Accessibility Survey

City of Downey Comolette Street - Barlin Avenue To Cul-de-sac

Date of Inspection
4/7/2017

Prepared By
Disability Access Consultants
(800) 743-7067

Brock Avenue North Crossing @ 33.919881549839, -118.152760863304

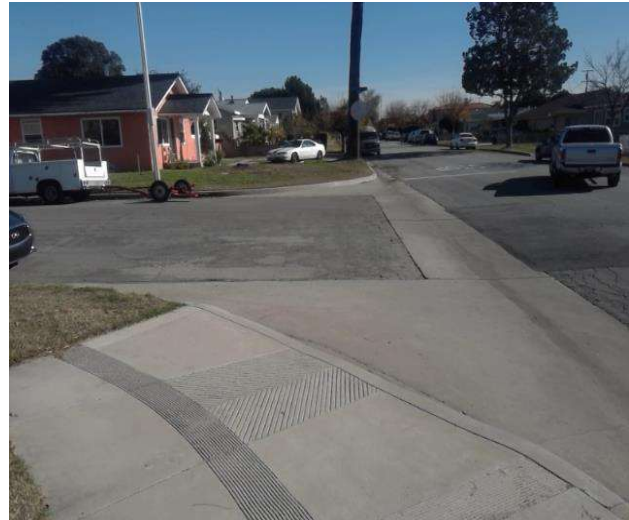
There are no detectable warnings where the pedestrian route crosses vehicular traffic.

On-Site Finding Not Found

Provide detectable warnings.

Change In Level East Of Downey Avenue @ 33.918595058249, -118.150588274002

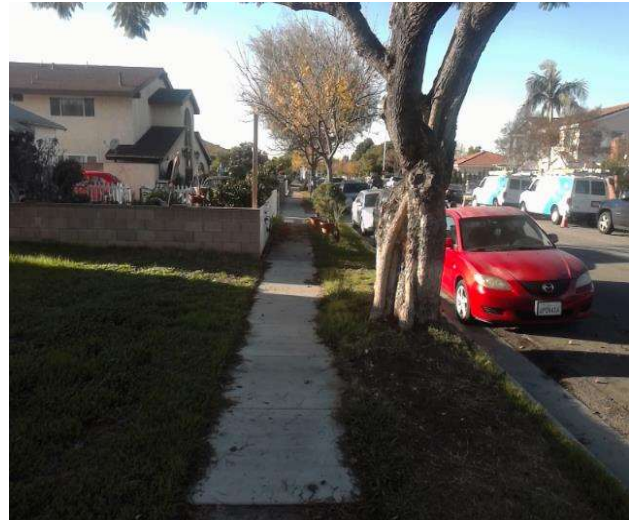
There is a change in elevation greater than recommended value.

On-Site Finding 0.50 inches

Ensure that the change in elevation is within the recommended value.
